COMMUNITY BOARD FEEDBACK PACKAGE

DINING OUT NYC

Business Name: MASSERIA DEI VINI

Application Number: 20240716010008

Sidewalk Cafe Site Plan Form

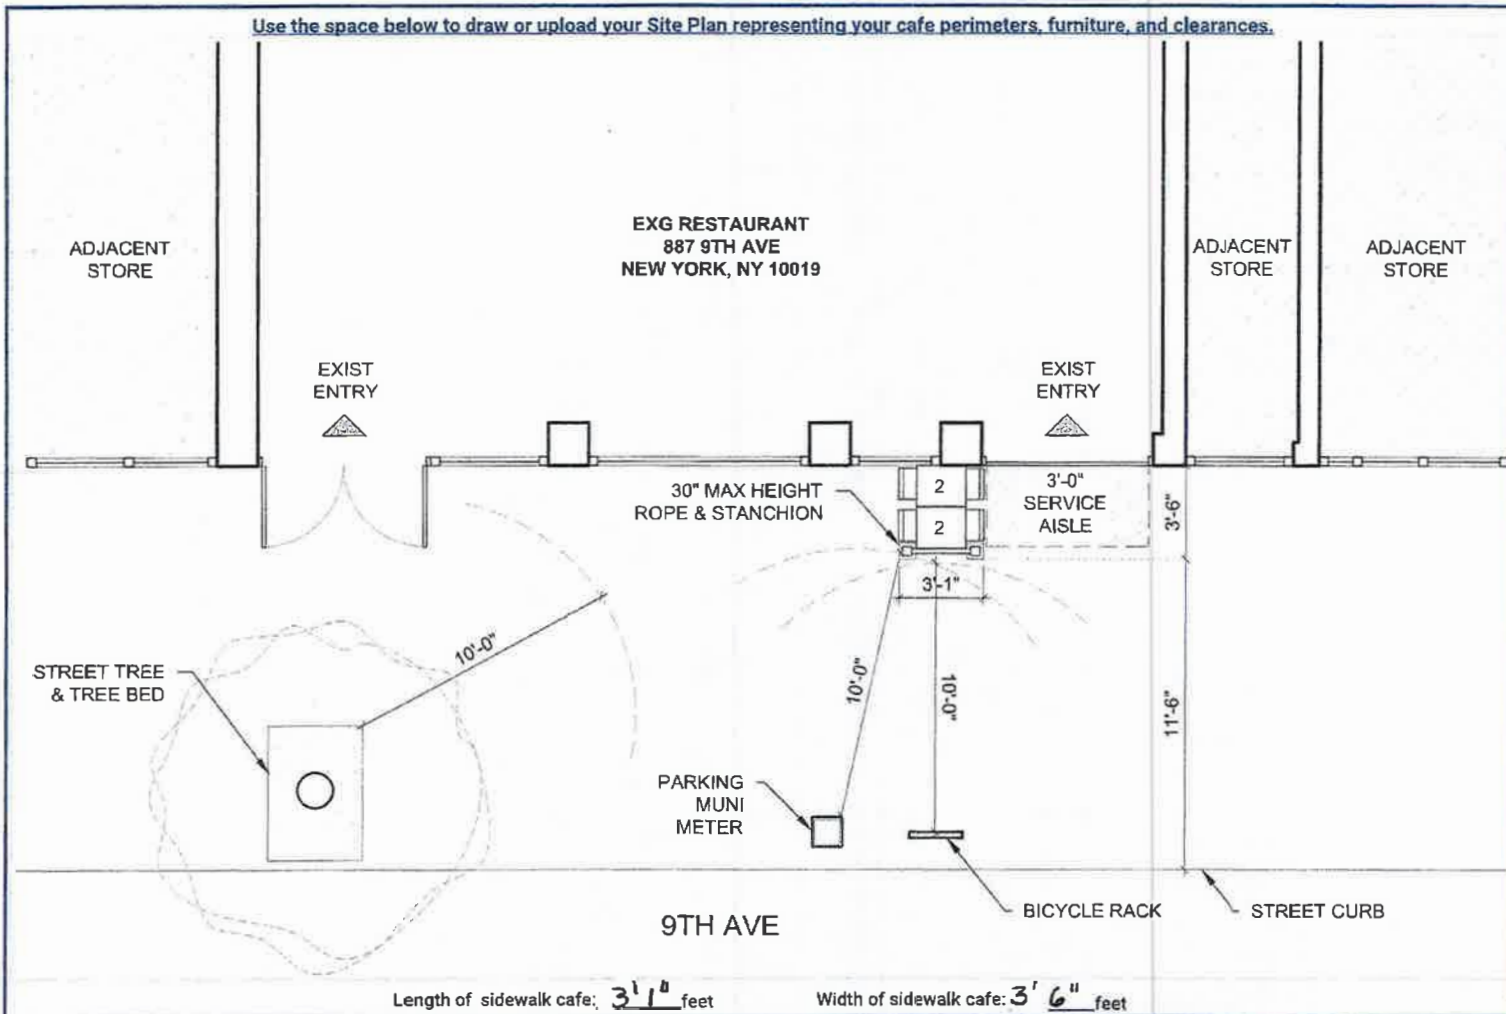
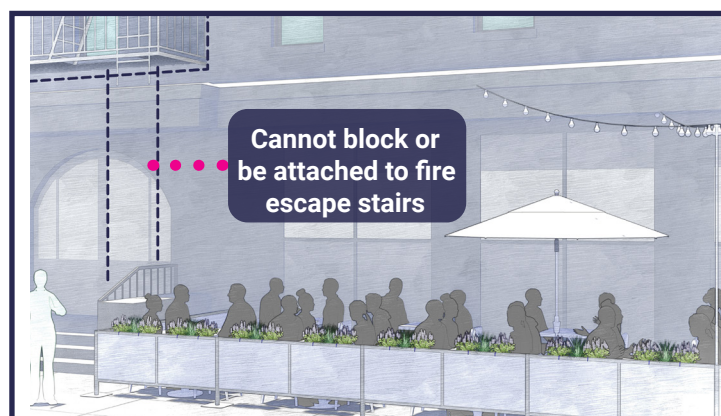
Measurements on the original Site Plan are incorrect and do not provide for the required 10 foot Clear Path between the sidewalk cafe perimeter and the curbside obstructions.

To provide for the required 10 foot Clear Path between the sidewalk cafe perimeter and the curbside obstructions, MCB4 requests that 1 table with 2 seats be removed from the cafe. The applicant has agreed to this change and prepared the attached Revised Site Plan limiting the cafe to 1 table with 2 seats.
